# **PROPOSED REDEVELOPMENT OF WILBERFORCE AVENUE CAR PARK AT 17 DOVER ROAD ROSE BAY NSW 2029**

**REPORT ON ENVIRONMENTAL HEALTH REFERRAL COMMENTS  
& RECOMMENDATIONS - DEVELOPMENT APPLICATION No.  
598/2022/1**

**Prepared by:  
Louie Salvatore  
Senior Environmental Health Officer  
Woollahra Municipal Council**

**05 OCTOBER 2023**

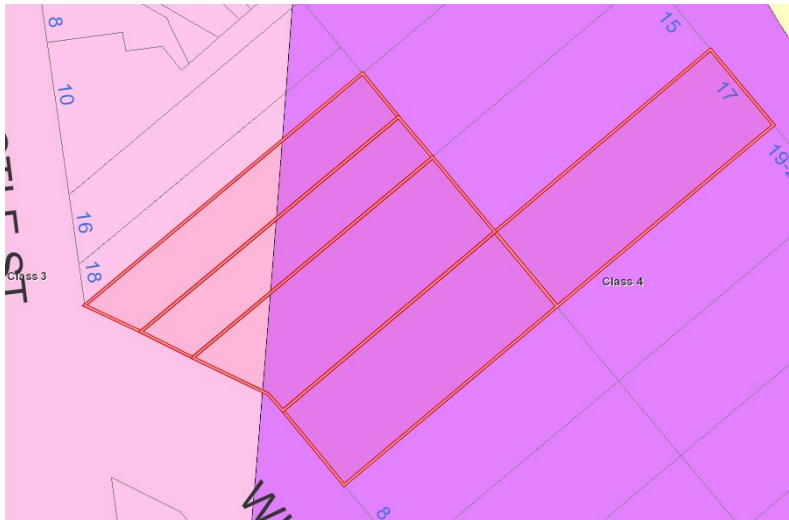
The architectural plans also reflect openings in the north-eastern façade (in line of sight with 7 Dover rd), which should be considered as part of the noise impact assessment. Should the façade opening remain as reflected in the architectural plans, the L<sub>max</sub> (sleep disturbance) should be predicted for cars near the façade openings.

Management controls and subsequent noise emissions of the rooftop carpark was raised as part of the review. Concerns with the management and enforcement of the rooftop carpark operating hours 10pm should also be considered. Moreover, L<sub>max</sub> (sleep disturbance) or detailed assessment of door close/car start may be conducted to ensure the parapet height is adequate to assess and avoid sleep disturbance for cars leaving after 10pm.

In light of the concerns raised in the Wilberforce Car Park – Review of Acoustic Reports for Development Application prepared by Renzo Tonin & Associates (dated 21/02/2023), Environmental Health has determined that the acoustic review prepared by SLR Consulting Australia Pty Ltd (dated 13/05/2022), SNIA prepared by PWNA (dated 10/02/2023) and Acoustic Response: Memorandum prepared by PWNA (dated 10/02/2023), is not satisfactory and that more information is required by the applicant with respect to above.

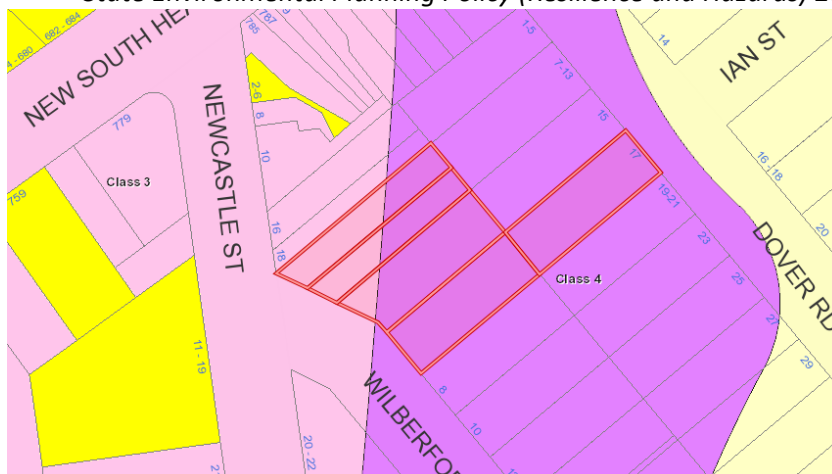
Three samples were sent for laboratory testing and analysed for SPOCAS to confirm the presence or absence of ASS or PASS in the soil. Results of testing was compared to the NSW ASSMAC Action Criteria with the assumption of >1000 tonnes of material are to be disturbed. Findings indicate no Acid Sulphate Soils are present within the subject site and accordingly, no Acid Sulphate Soils management plan is required.

Based on the findings of the laboratory analysis, Environmental Health has determined that there is not Acid Sulphate Soils present within the proposed site and thus an Acid Sulphate Soils Management Plan is not necessary.
